ST/SG/AC.10/36/Add.2/Corr.1
2 September 2009

**REPORT OF THE COMMITTEE OF EXPERTS ON THE TRANSPORT OF
DANGEROUS GOODS AND ON THE GLOBALLY HARMONIZED SYSTEM OF
CLASSIFICATION AND LABELLING OF CHEMICALS ON ITS FOURTH SESSION
(Geneva, 12 December 2008)**

Amendments to the fourth revised edition of the Recommendations on the Transport of
Dangerous Goods, Manual of Tests and Criteria (ST/SG/AC.10/11/Rev.4)

Corrigendum

8. Page 17, Figure A7.1

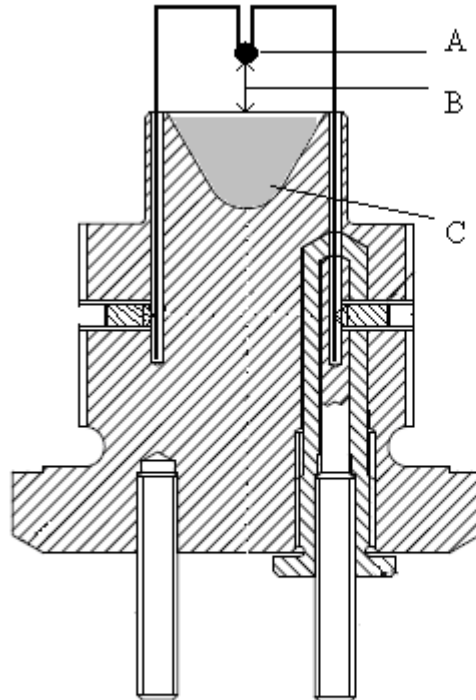
Replace Figure A7.1 with the figure below.

-
- (A) Fusehead
(B) 10 mm gap
(C) Substance under test
-

9. Page 18, Figure A7.2

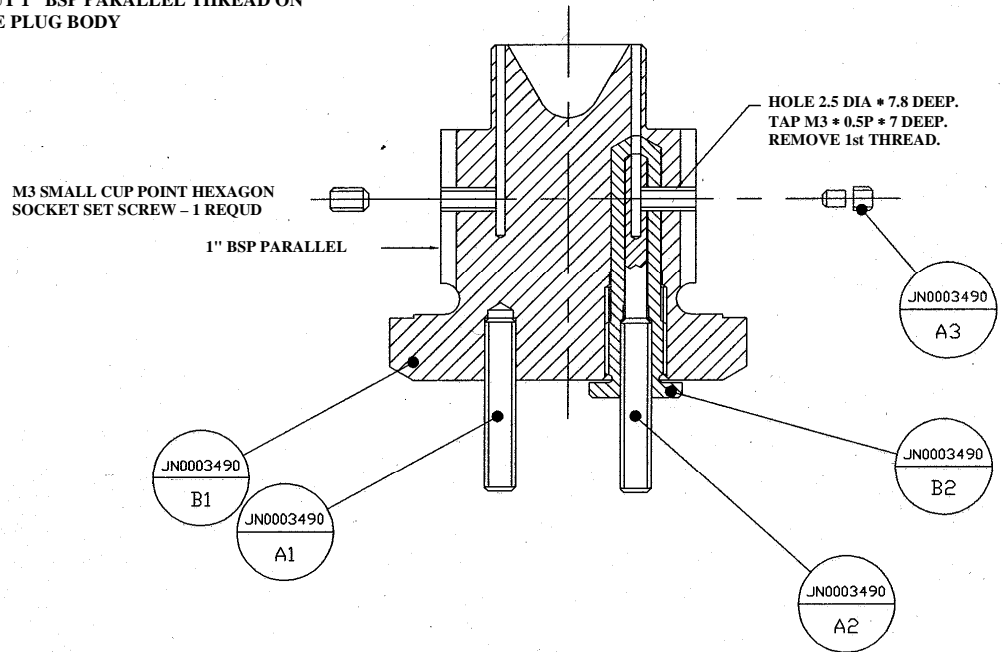
Replace Figure A7.2 with the figure below.

11. Page 20, Figure A7.4

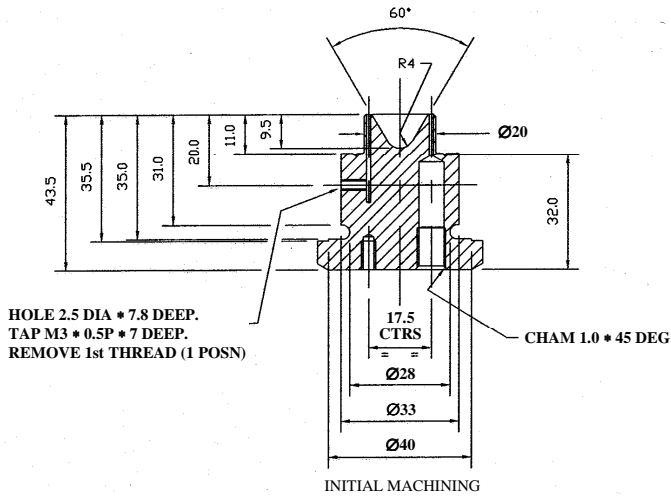
Replace Figure A7.4 with the figure below.

HOLE 2.5 DIA * 7.8 DEEP.
TAP M3 * 0.5P * 7 DEEP.
REMOVE 1st THREAD (1 POSN)

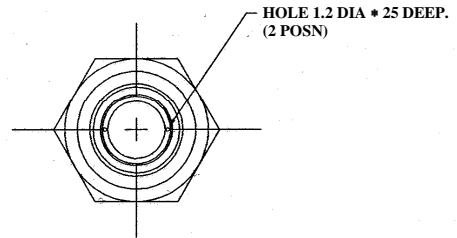
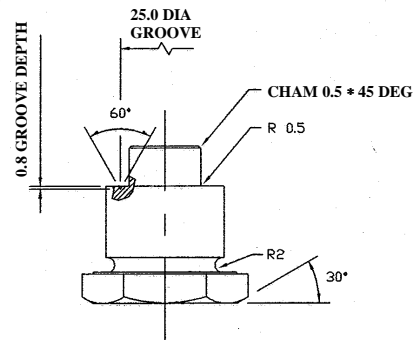
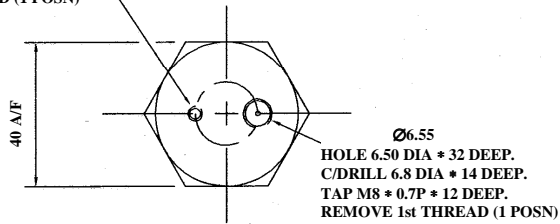
HOLE 3.3 DIA * 10 DEEP.
TAP M4 * 0.7P * 8 DEEP.
REMOVE 1st THREAD (1 POSN)

12. Page 21, Figure A7.5

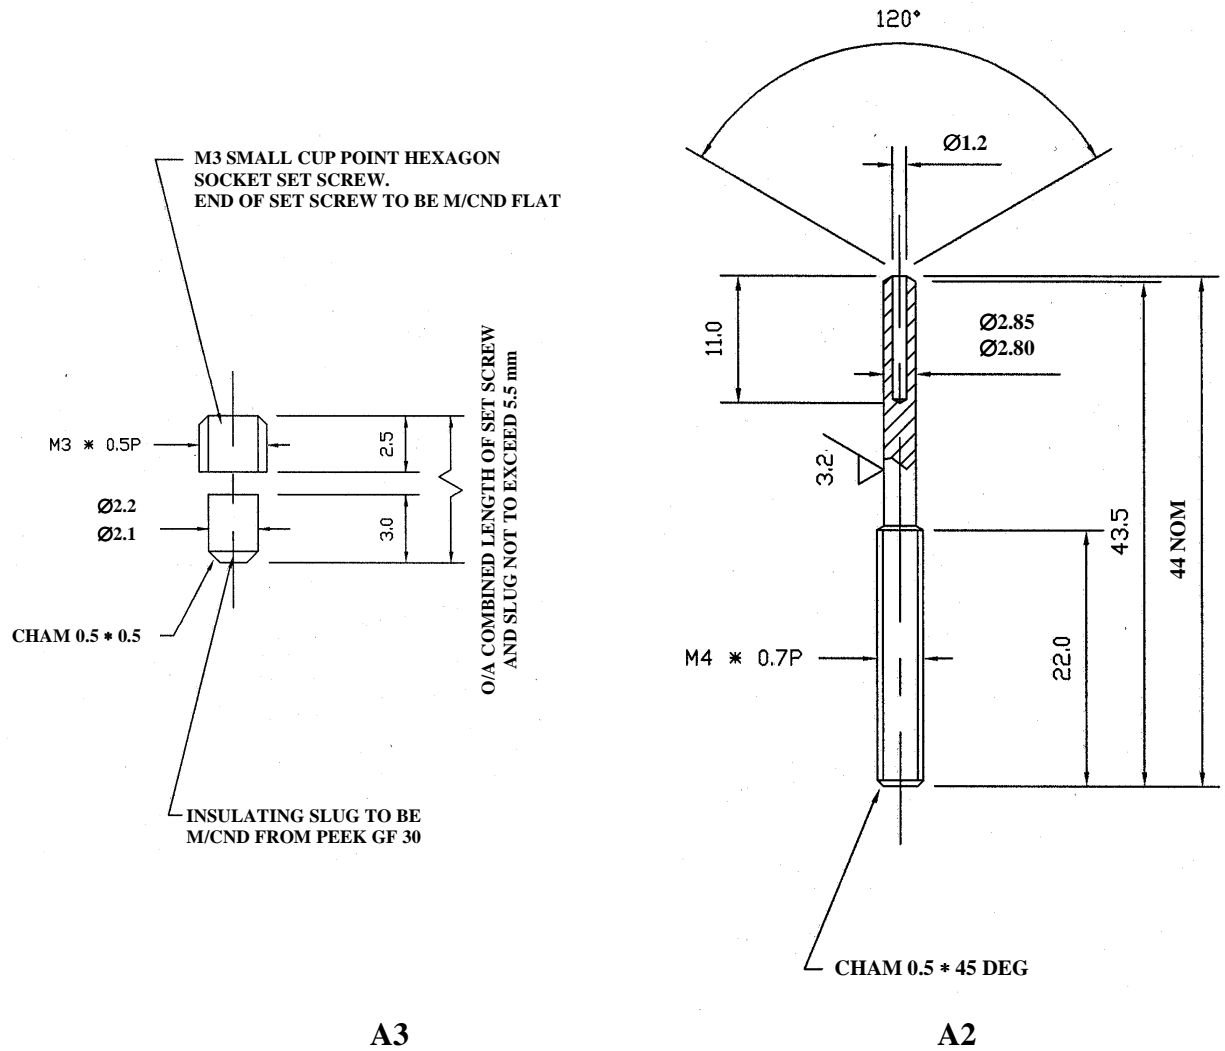
Replace Figure A7.5 with the figure below.

13. Page 22, Figure A7.6

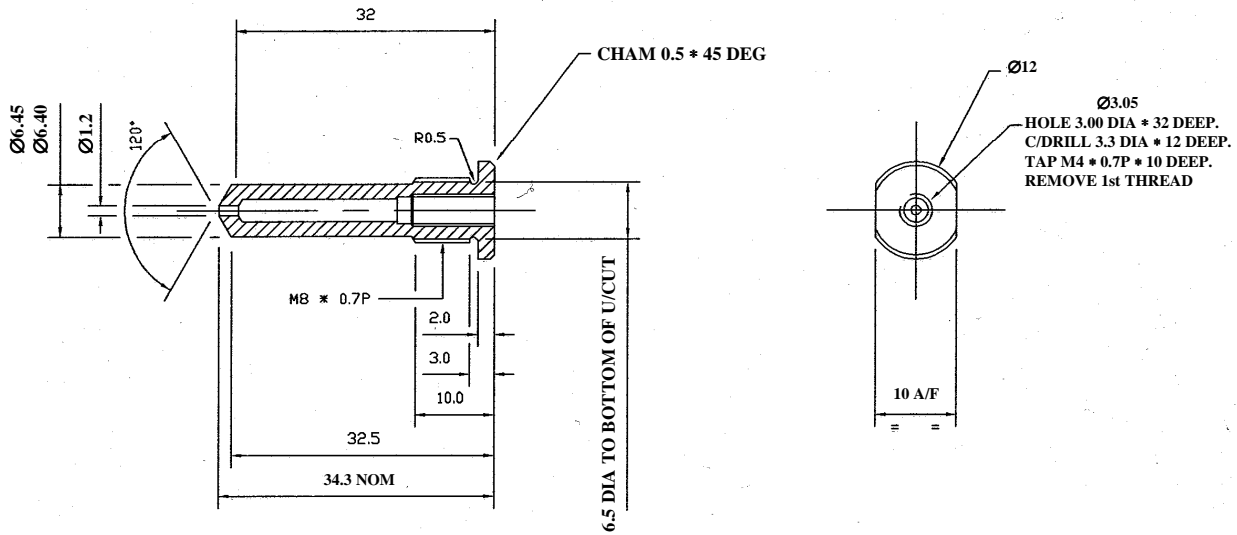
Replace Figure A7.6 with the figure below.

14. Page 22, Figure A7.7

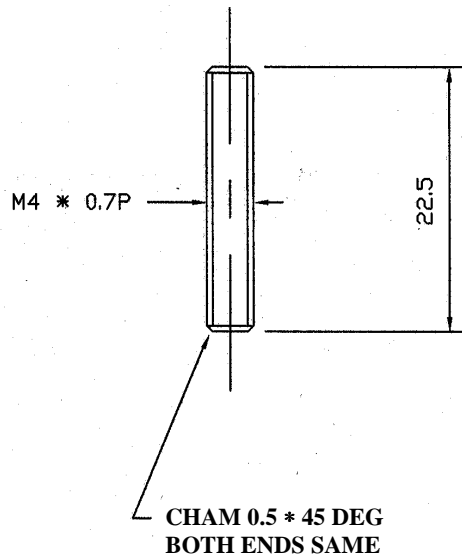
Replace Figure A7.7 with the figure below.

Figure A7.8: ASSEMBLED CONE IN PLUG

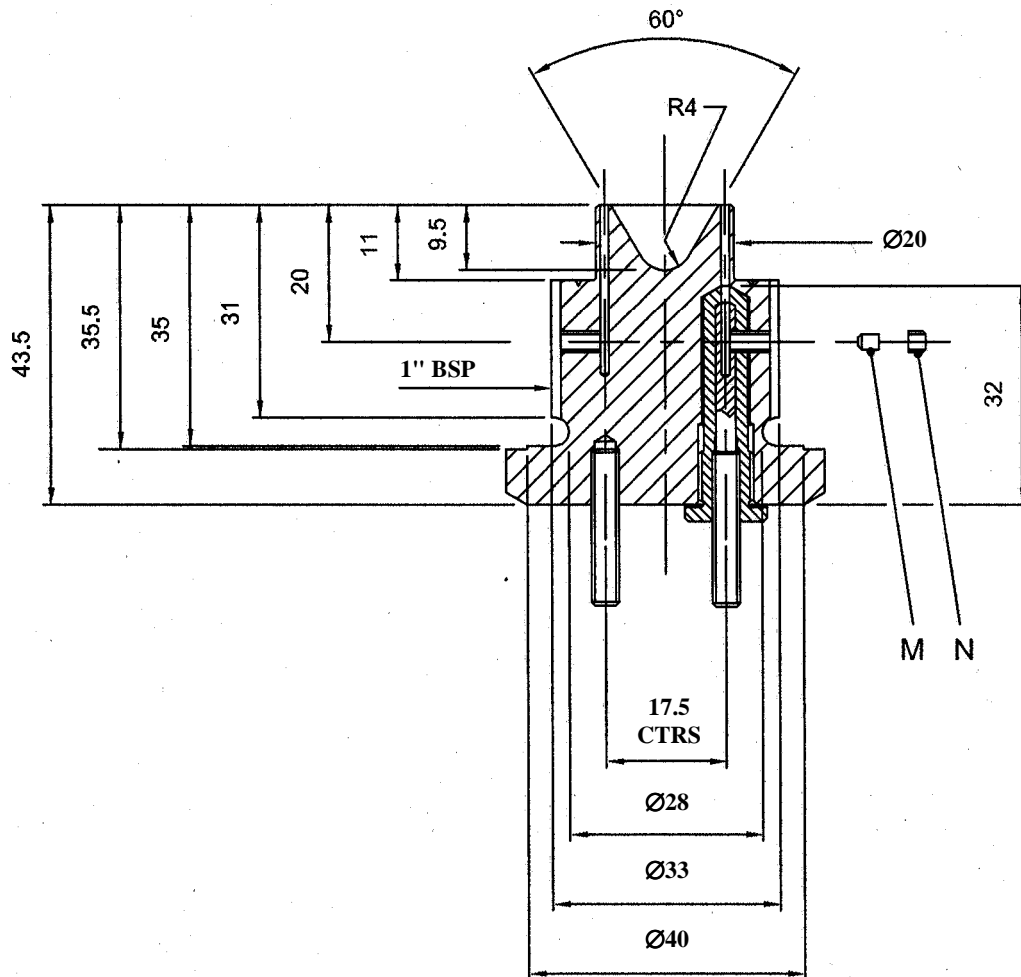
15. Page 23, before existing Figure A7.8

Insert a new Figure A7.8 reading
